APPLICATION NO.	FILING DATE	FIRST NAMED INVENTOR	ATTORNEY DOCKET NO.	CONFIRMATION NO.
10/723,487	11/26/2003	Scott A. McCuskey	SAMC 63916	9528

Office Action Summary	Application No.	Applicant(s)	
	10/723,487	MCCUSKEY ET AL.	
	Examiner	Art Unit	
	Gwendolyn Baxter	3632

This is the third Office of application serial number 10/723,487, Weapon Caddy, filed November 26, 2003.

Sheet 2 of 7

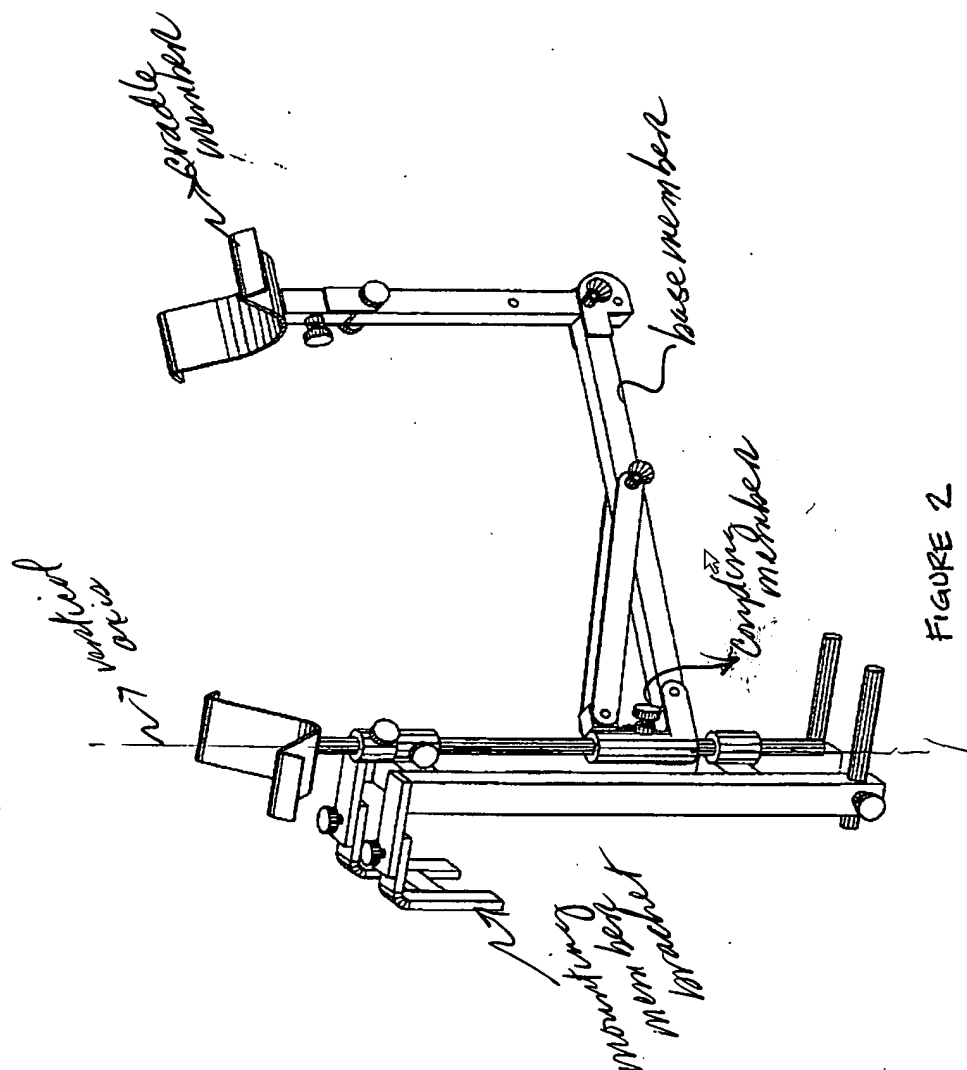
Claims 1 and 7 are rejected under 35 U.S.C. 102(b) as being anticipated by U.S. Patent No. 5,778,589 to Teague. The present invention reads on Teague as follows: Teague teaches a caddy comprising a mounting bracket (20), a base member (30), and a cradle member (45). The mounting bracket is structured and arranged for mounting on a support structure (11). The base member is slidably mounted on the mounting bracket. A coupling (40) is between the mounting bracket and the base member, which permits both sliding and rotating movement between the mounting bracket and the base member at a single point of connection between the mounting bracket and base member. The cradle member is mounted on the base member and structured and

arranged for supporting the weapon. The base member is rotatable around a substantially vertical axis when the mounting bracket is mounted on the support structure. See below.
